Form 3160-5  
(August 2007)UNITED STATES  
DEPARTMENT OF THE INTERIOR  
BUREAU OF LAND MANAGEMENTFORM APPROVED  
OMB No. 1004-0137  
Expires July 31, 2010**SUNDRY NOTICES AND REPORTS ON WELLS**  
*Do not use this form proposals to drill or to re-enter an abandoned well. Use Form 3160-3 (APD) for such proposals.*

| 4. Location of Well (Footage, Sec., T,R,M, or Survey Description)<br>2135 FSL & 330 FEL, Sec. 20 T16S R29E                      |                                                    | 8 Well Name and No.<br>Steelers Federal Com #1                 |

Mack Energy would like an extension of this APD for a period of two years.

## PECOS DISTRICT CONDITIONS OF APPROVAL

### **Cross Section of a Typical Lead-off Ditch**

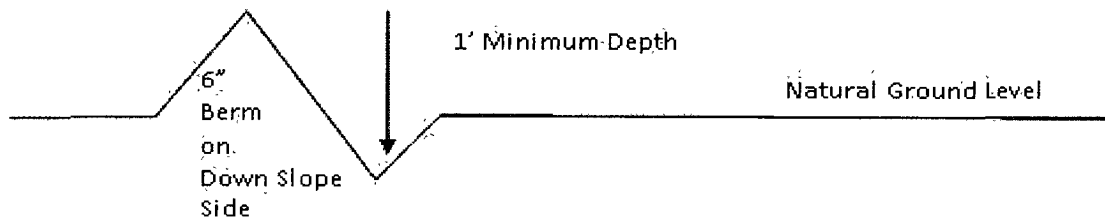
A typical lead-off ditch has a minimum depth of 1 foot below and a berm of 6 inches above natural ground level. The berm shall be on the down-slope side of the lead-off ditch.

All lead-off ditches shall be graded to drain water with a 1 percent minimum to 3 percent maximum ditch slope. The spacing interval are variable for lead-off ditches and shall be determined according to the formula for spacing intervals of lead-off ditches, but may be amended depending upon existing soil types and centerline road slope (in %);

Figure 1 – Cross Sections and Plans For Typical Road Sections

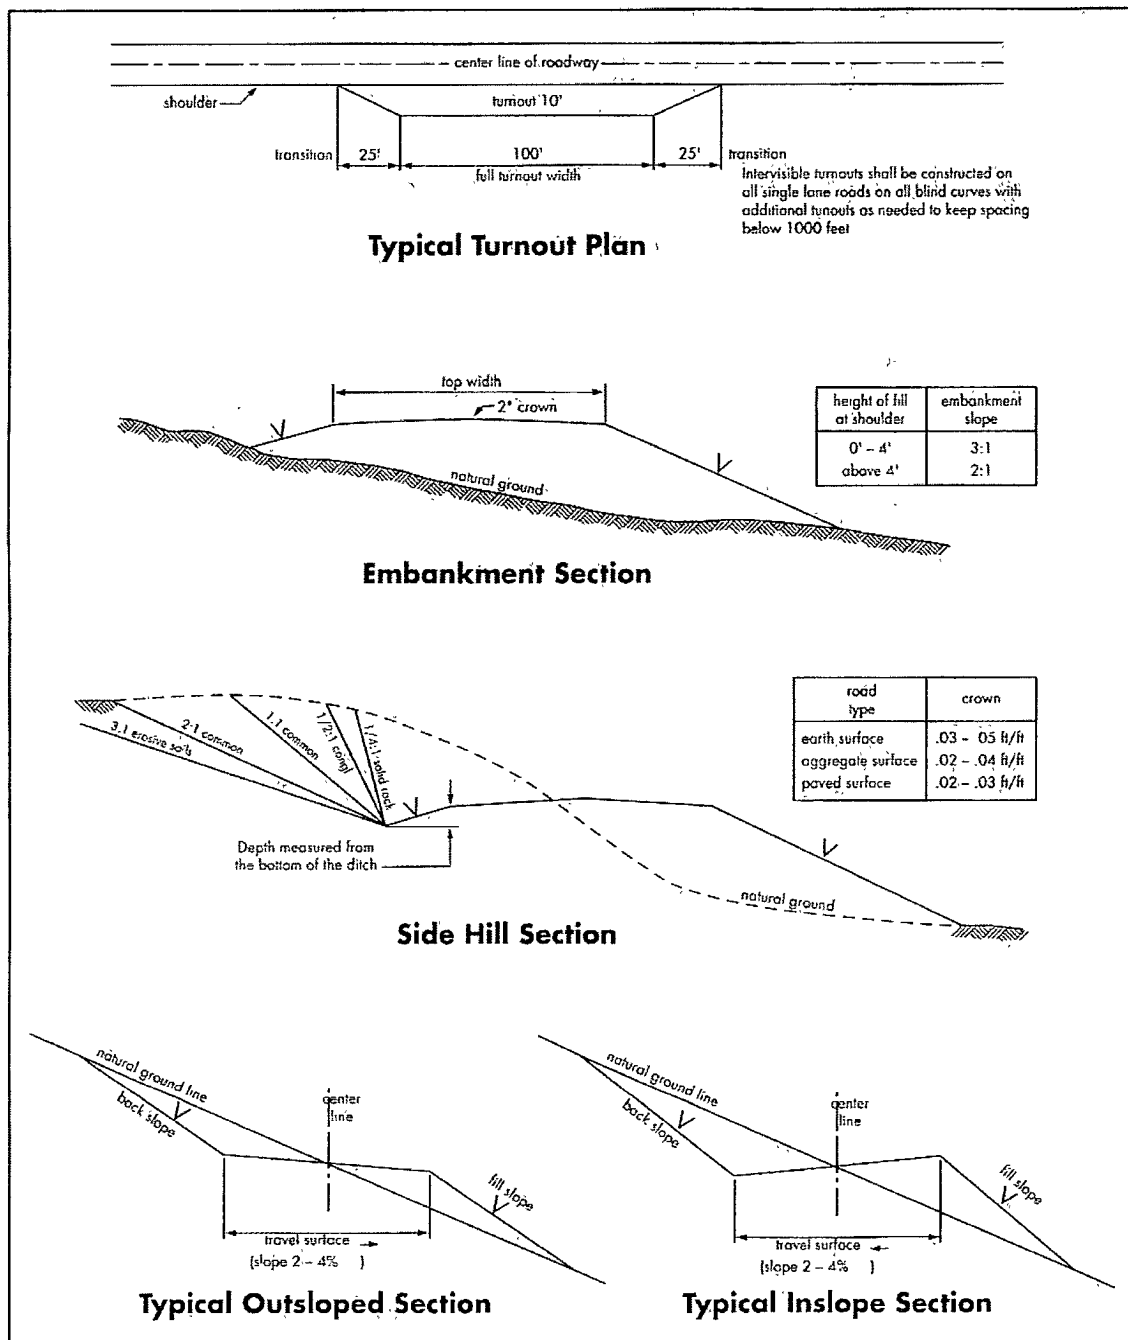
Crowning shall be done on the access road driving surface. The road crown shall have a grade of approximately 2% (i.e., a 1" crown on a 14' wide road). The road shall conform to Figure 1; cross section and plans for typical road construction.
